RE: Final Decision and Corrective
Measures Implementation Order
EKCO Housewares, Inc.
OHD 045 205 424

**FINAL DECISION AND
RESPONSE TO COMMENTS**

ATTACHMENT II
U.S. EPA RESPONSE TO COMMENTS

FIGURE 1
ANNOTATED GEOLOGIC
CROSS SECTION A-A'
AT THE EKCO HOUSEWARES PLANT,
MASSILLON, OHIO

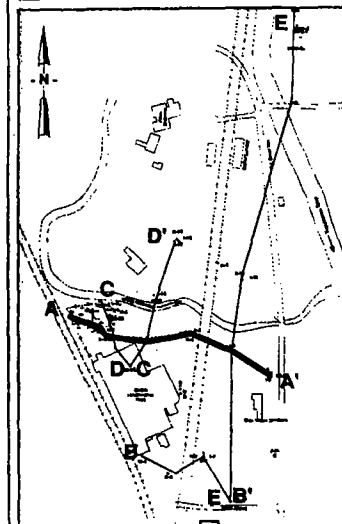
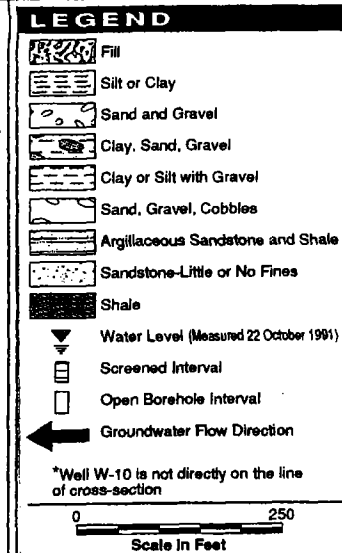
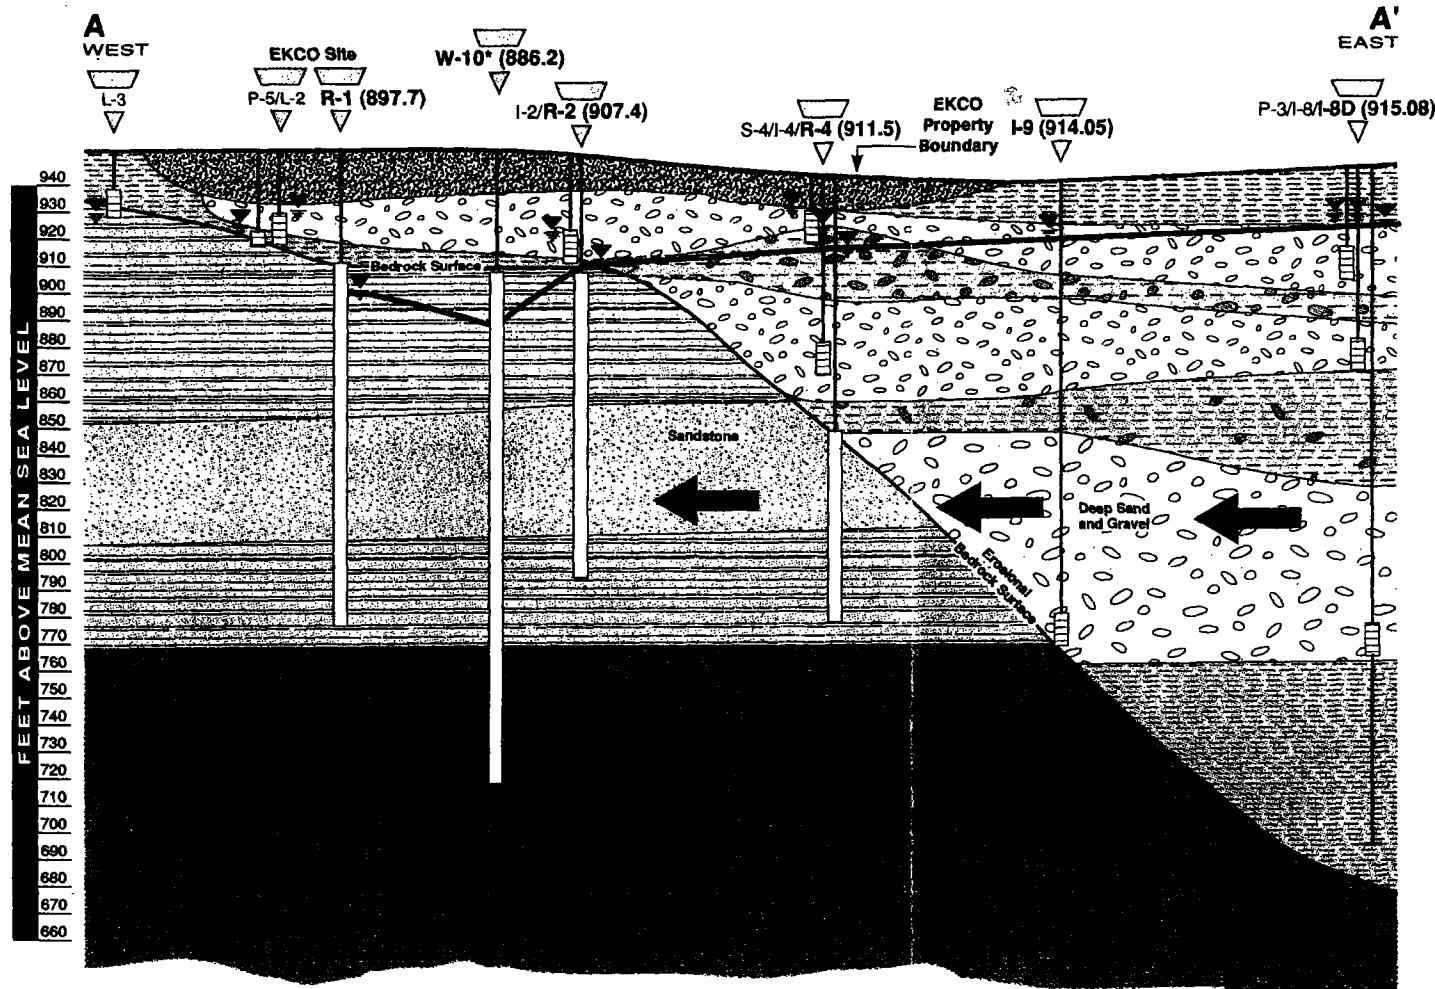
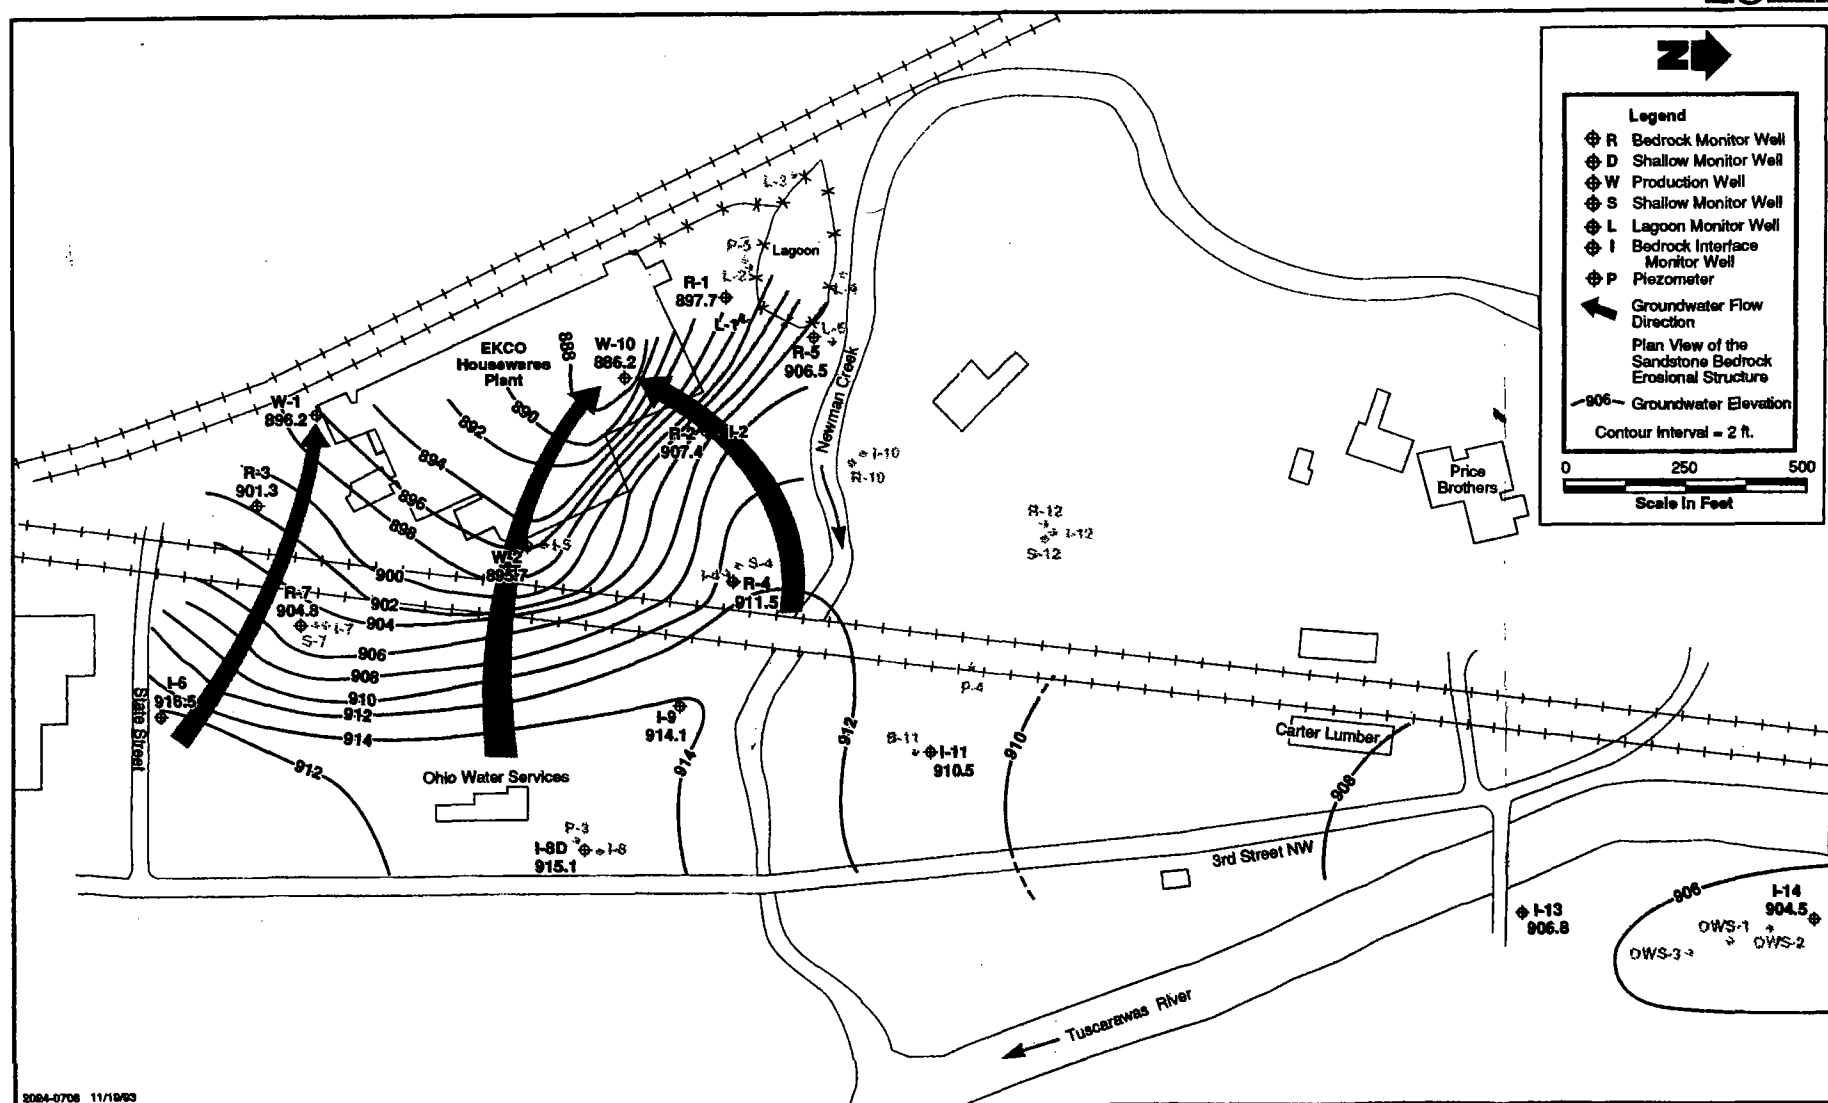
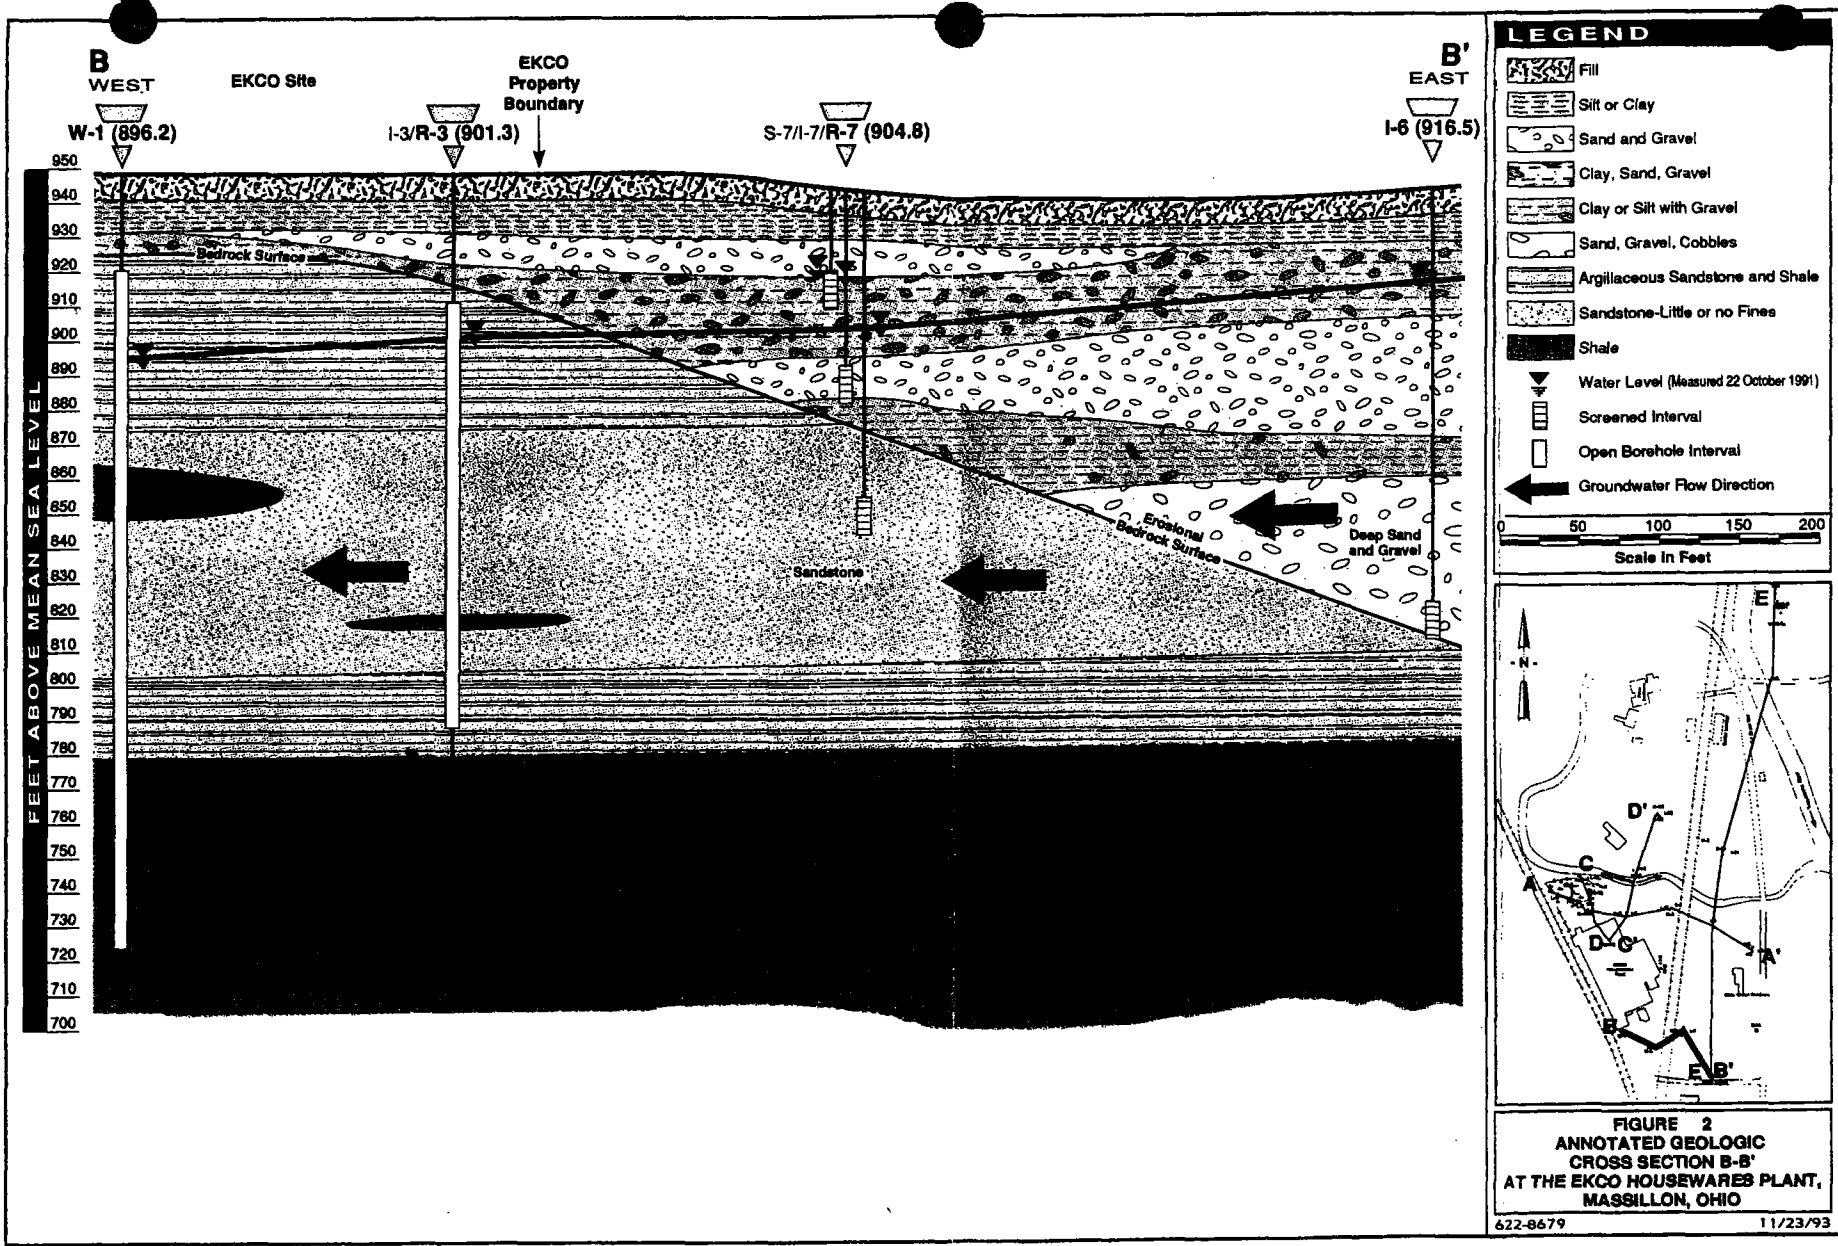
The attached Figures 1, 2 and 3 from the final CMS show that the EKCO recovery wells (W-1 and W-10) do have an impact on the deep unit east of the facility. These figures show that the EKCO recovery wells induce a significant gradient from the deep unit east of the facility back toward the site. These figures clearly show that the EKCO recovery wells prevent any off-site migration and also pull groundwater from the deep unit toward the site.

The attached Figures 1, 2 and 3 from the final CMS show that the EKCO recovery wells (W-1 and W-10) do have an impact on the deep unit east of the facility. These figures show that the EKCO recovery wells induce a significant gradient from the deep unit east of the facility back toward the site. These figures clearly show that the EKCO recovery wells prevent any off-site migration and also pull groundwater from the deep unit toward the site.

U.S. EPA Response: Figures 1, 2, and 3 from the final CMS are part of Appendix A in which EKCO disputes the findings and conclusions of the RFI and CMS. The RFI concluded that the on-site recovery wells do not have any effect on the deep sand gravel layer that overlies the bedrock and that the flow system in this interval is governed by the OWS wells, which pull the groundwater to the north. U.S. EPA stands by its initial conclusion.

FIGURE 4 EXTENT OF GLACIAL VALLEY

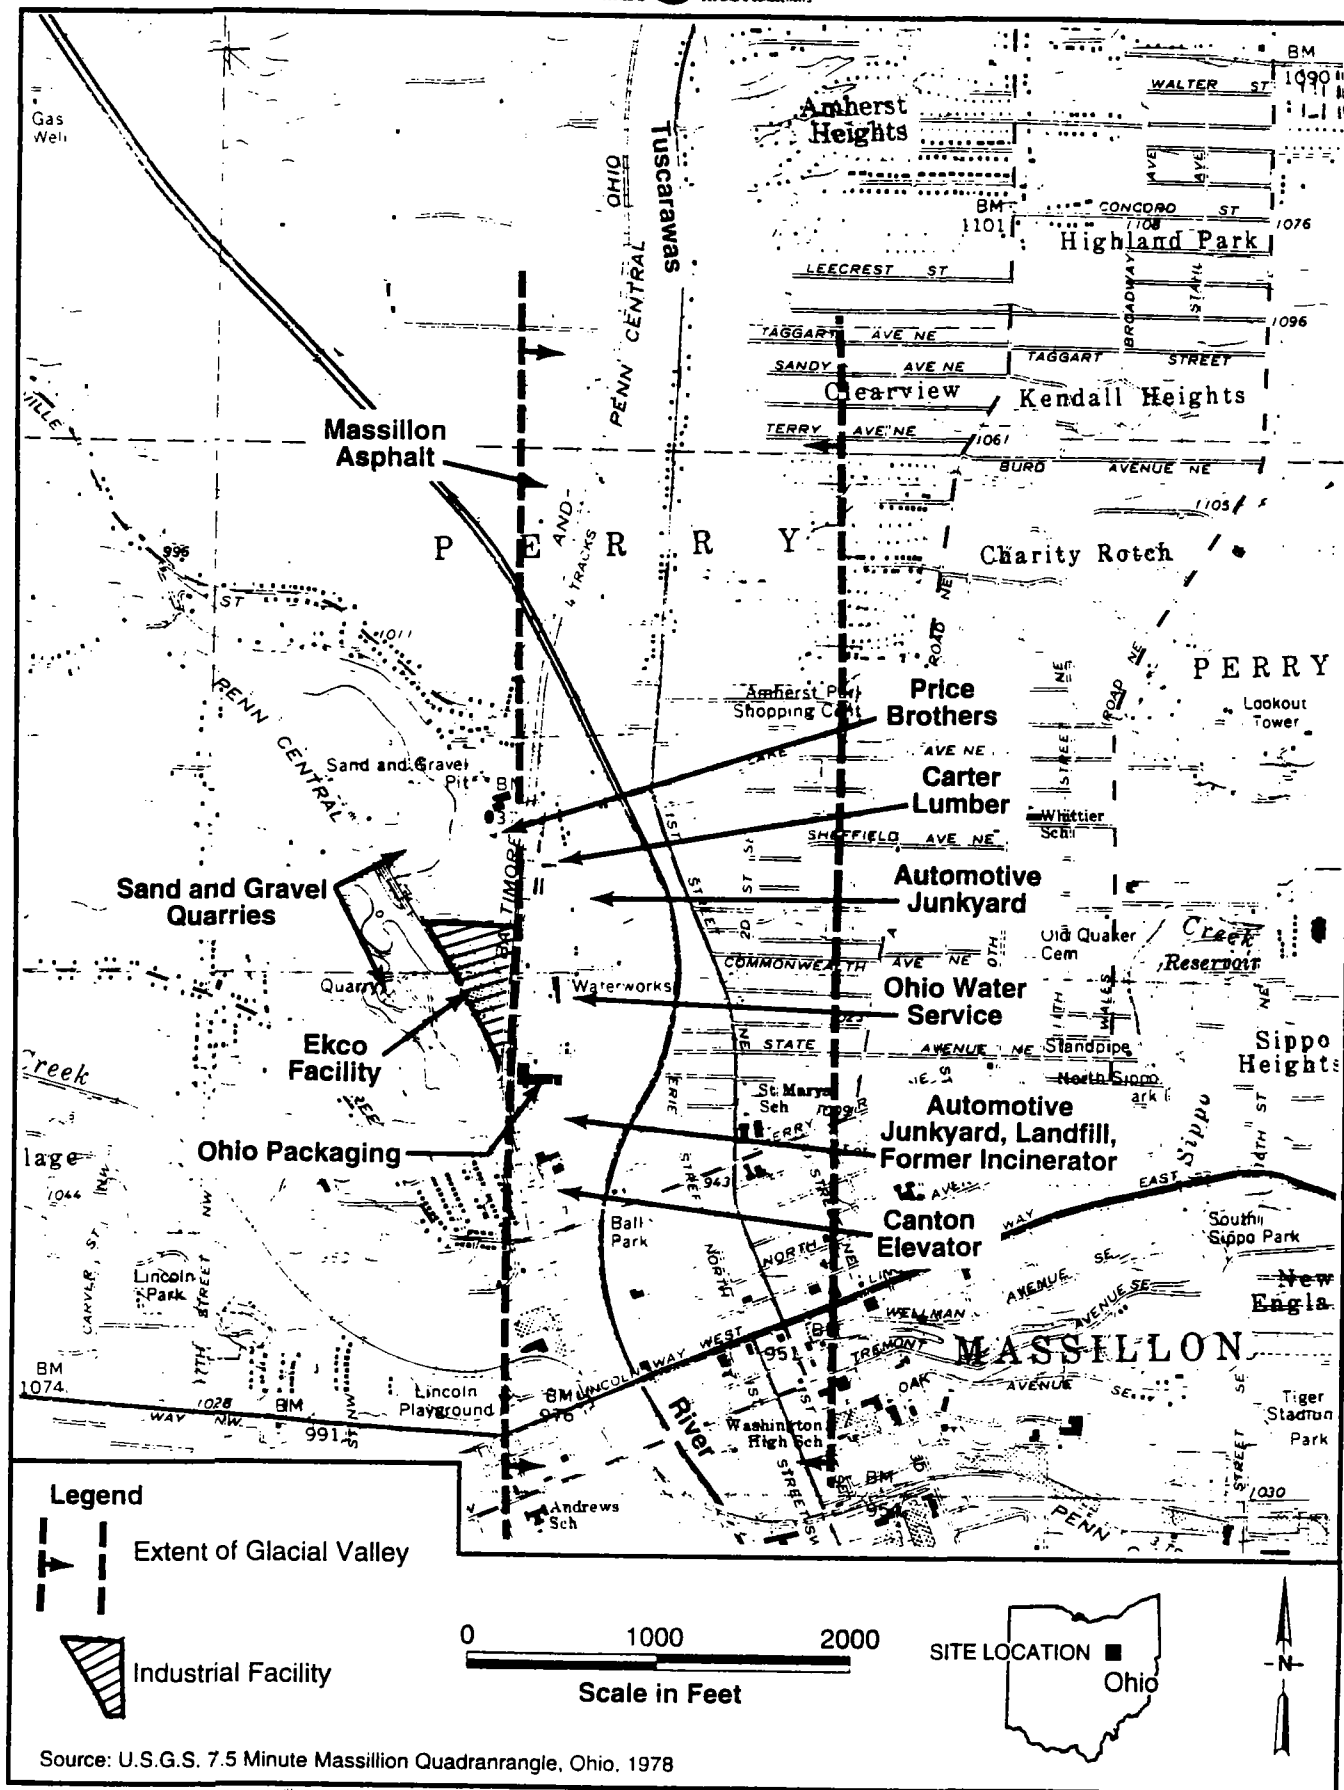
Comment 3: "Figure 4 (attached) shows that the extent of the glacial valley from which OWS draws its groundwater extends throughout the industrial Massillon area. It can be seen in this figure that within the glacial valley there are abundant potential sources of VOCs to the groundwater. Industrial facilities located within the glacial valley are much more likely sources of the contamination found at the OWS-4 well than the EKCO facility, which is located west of the glacial valley and has a pumping system that pumps significantly more water than is necessary to prevent off-site contaminant migration."

Figure 4 (attached) shows that the extent of the glacial valley from which OWS draws its groundwater extends throughout the industrial Massillon area. It can be seen in this figure that within the glacial valley there are abundant potential sources of VOCs to the groundwater. Industrial facilities located within the glacial valley are much more likely sources of the contamination found at the OWS-4 well than the EKCO facility, which is located west of the glacial valley and has a pumping system that pumps significantly more water than is necessary to prevent off-site contaminant migration.

U.S. EPA Response: The facilities identified on the map do not have RCRA identification numbers and are not known to have handled the constituents that have contaminated OWS-4. However, this fact does not preclude the facilities of having been responsible for unknown contaminant releases to the environment.
